# PRODUCT ADVISORY NOTICE

**SUBJECT: Temporary color change of 76HP, 90B and 90HB DIP actuators due to plastic material shortage**

DIP Actuator Temporary Color Change Due to Material Shortage

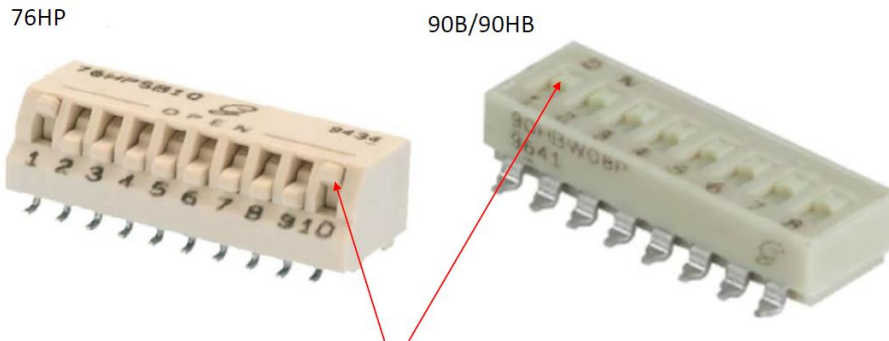
Due to a shortage of the natural colored plastic material used to mold the actuators of the affected DIP switches, the color will be temporarily changed to black to avoid production delays.

Color of DIP actuators (currently natural) will be temporarily changed to black to prevent production delays.

There is no change to the form, fit, or function of the products. The parts will be produced using the same plastic material, only in an alternative color (black).
